EASTWOOD VILLAGE COUNCIL (EVC) EXECUTIVE BOARD'S COMMENTS
REGARDING THE REQUEST FOR VARIANCE/WAIVERS
FOR SPRINGDALE AUTOMOTIVE – EASTWOOD
Case No: 15Variance 1014
APRIL 6, 2015

REQUIRED ROUTE TO GET FROM
FRONT TO REAR

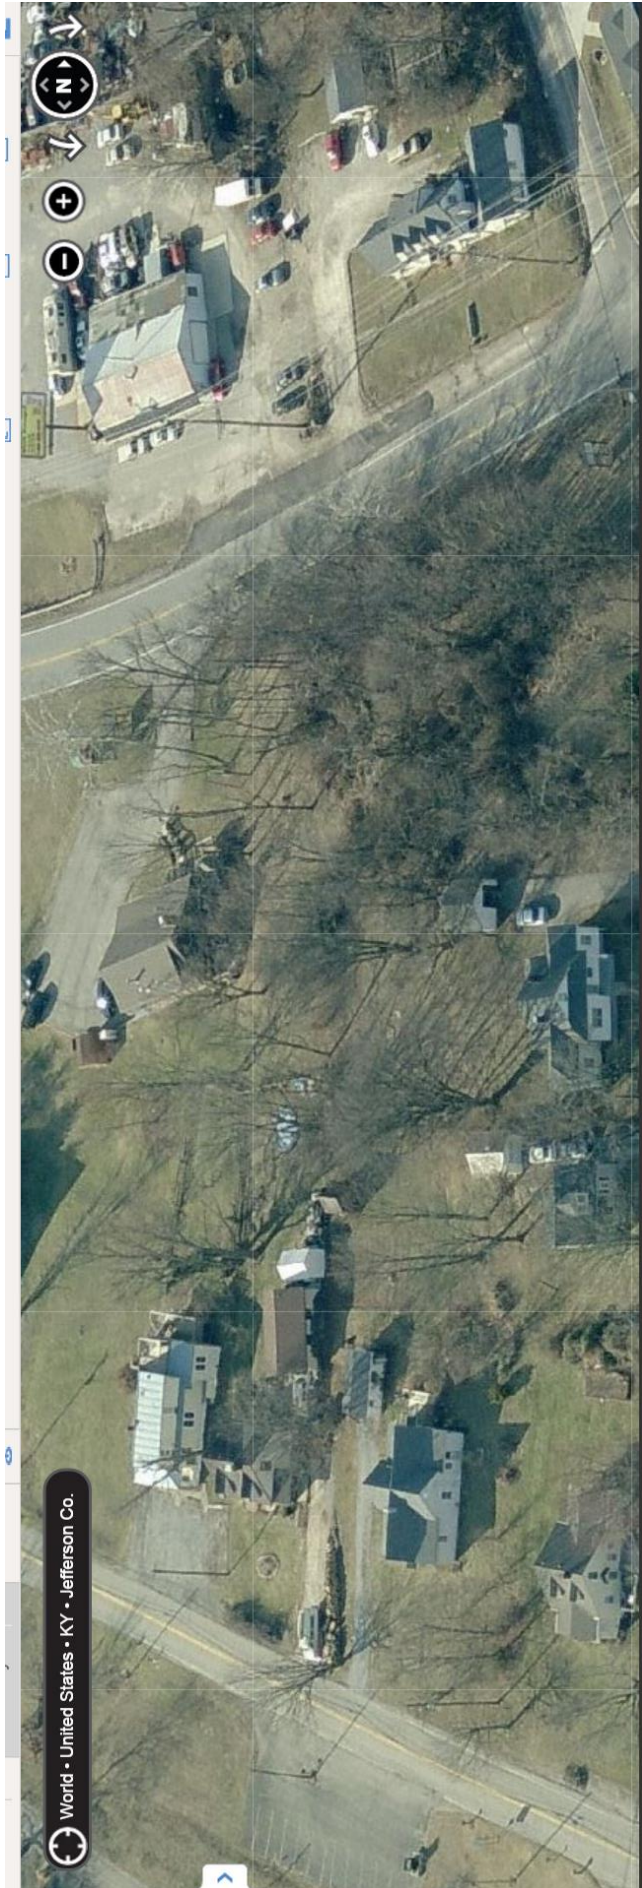
- a) setback to enable entry point "cut" off Shelbyville Road is **unsafe** and may add to the already high accident rate; cut is too close to Johnson Road;

- 1) Where do the employees park?
- 2) Where do the tenants park?
- 3) Proximity of the proposed Shelbyville "cut" to Johnson Road intersection may add to the already high number of accidents occurring along this stretch of Shelbyville Road (per the FD station personnel).
